SUBDIVISION AUTHORITY MINUTES

RE: Tentative plan of subdivision to create 204 low density residential lots and two municipal reserve lots from portions of SW-22-51-24-4 and Plan 7920978 Lot 1 located east of 88 Street SW and north of 25 Avenue SW; **SUMMERSIDE**

SUBDIVISION CONDITIONS OF APPROVAL MAP

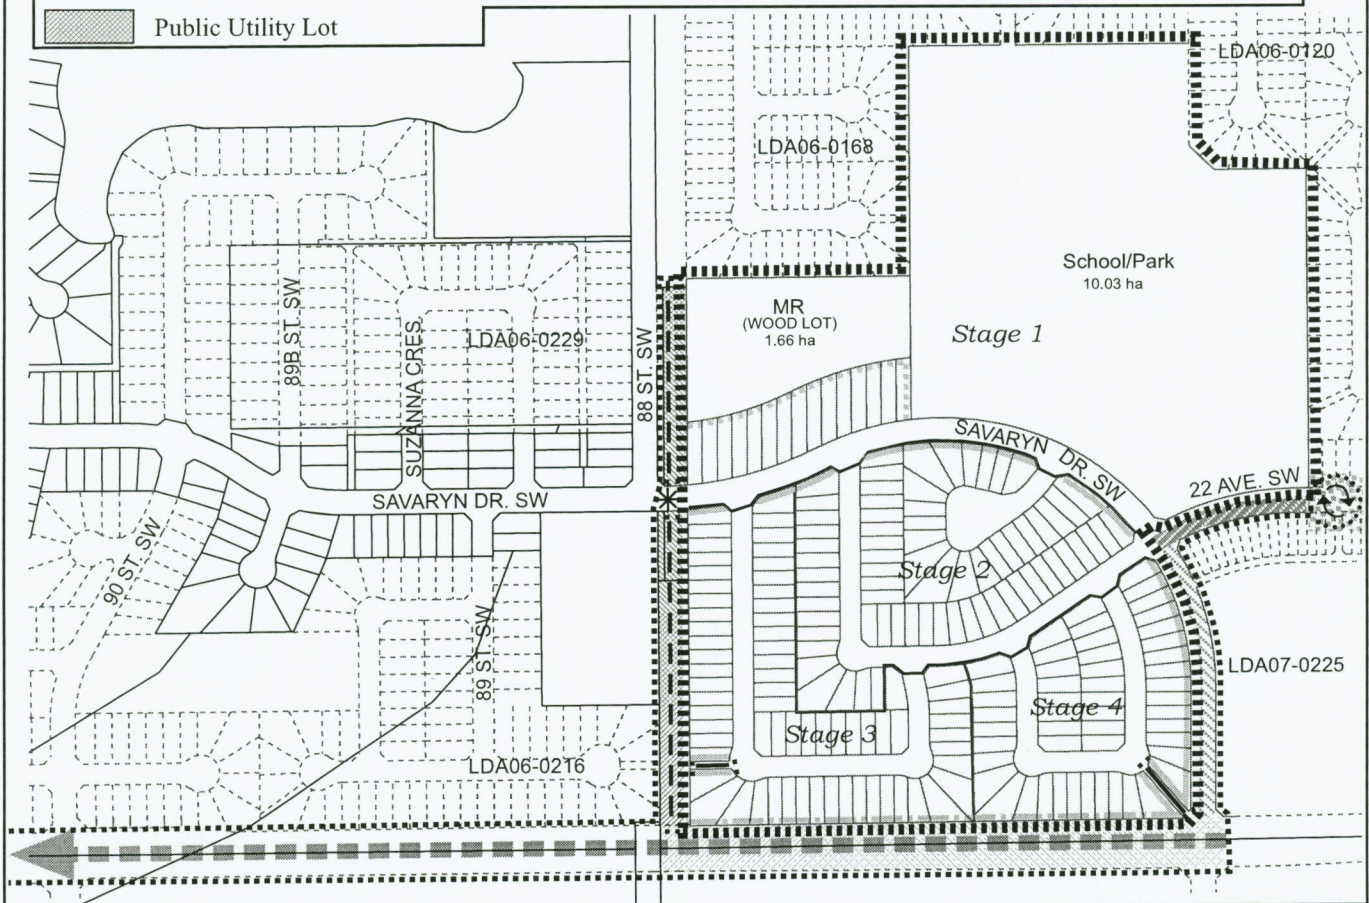
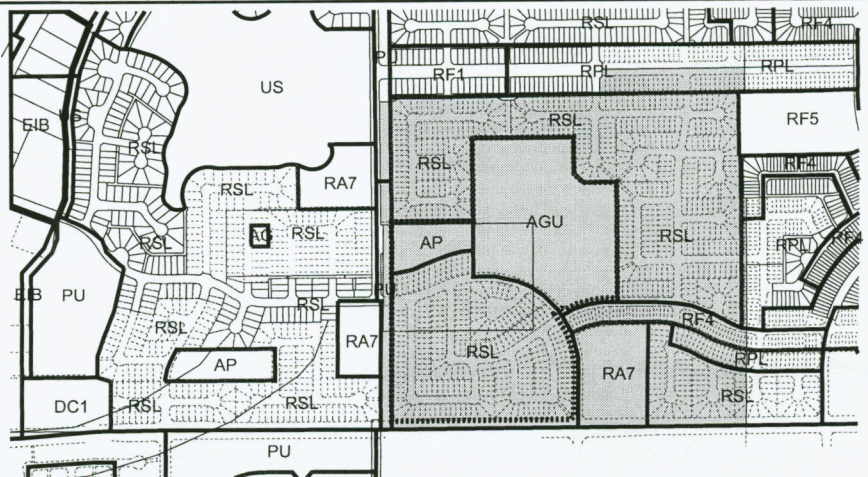
1. that the owner dedicate Municipal Reserve as 1.66 and 10.03 ha parcels pursuant to Section 666 of the Municipal Government Act as shown on the "Conditions of Approval" map, Enclosure I;

5. that the subdivision boundary be amended to include the road right-of-way dedication and that portion of the power line right-of-way that abuts this subdivision, as shown on the "Conditions of Approval" map, Enclosure I;

6. that the property line and road right-of-way dedication conform to an approved Concept Plan or to the satisfaction of the City of Edmonton for 25 Avenue SW from Savaryn Drive to the transmission line right-of-way, as shown on the "Conditions of Approval" map, Enclosure I;

8. that the owner be permitted to register this plan of subdivision in stages, as shown on the "Conditions of Approval" map, Enclosure I, at the discretion of the Chief Subdivision Officer, having regard to the provision of roadways and the logical extension of services;

6. that the owner construct 22 Avenue SW from Savaryn Drive to the east edge of the school/park site (with a mono-walk with straight faced curb and gutter along Savaryn Drive/22 Avenue adjacent to the school/park area to accommodate pick-up/drop-off activity) with development of Stage 1, as shown on the "Conditions of Approval" map, Enclosure I;

7. that the owner construct a 3 m asphalt multi-use trail with a dividing yellow centerline and "Shared Use" signage from north of the MR parcel to Savaryn Drive with development of Stage 1, as shown on the "Conditions of Approval" map, Enclosure I;

8. that the owner construct with Stage 1, a marked crosswalk with curb extensions, ramps and pedestrian signage, as shown on the "Conditions of Approval" map, Enclosure I;

9. that the owner construct Savaryn Drive from 22 Avenue SW to 25 Avenue SW and two lanes of 25 Avenue to a divided urban arterial roadway standard from Savaryn Drive to the urbanized section of 25 Avenue SW to the west, with the development of Stage 3 (the arterial road must be operational and open to traffic, with all lighting installed and energized no later than 3 years after the Servicing

10. that the owner construct a 3 m asphalt multi-use trail with a dividing yellow centerline and "Shared Use" signage from Savaryn Drive to 25 Avenue SW with development of Stage 3, as shown on the "Conditions of Approval" map, Enclosure I;

11. that the owner construct walkways with 1.5 m concrete sidewalks with bollards, lighting and 1.8 m uniform fencing to be provided within residential property lines, as shown on the "Conditions of Approval" map, Enclosure I;

12. that the owner construct an offset 17 m radius asphalt temporary transit turnaround with bollards with Stage 1, as shown on the "Conditions of Approval" map, Enclosure I. The temporary turnaround will be required at FAC or earlier, at the discretion and direction of the Transportation Department;

16. that the owner construct all fences positioned wholly on privately-owned lands to the satisfaction of the Asset Management and Public Works Department in the location as shown on the "Conditions of Approval" map, Enclosure I.
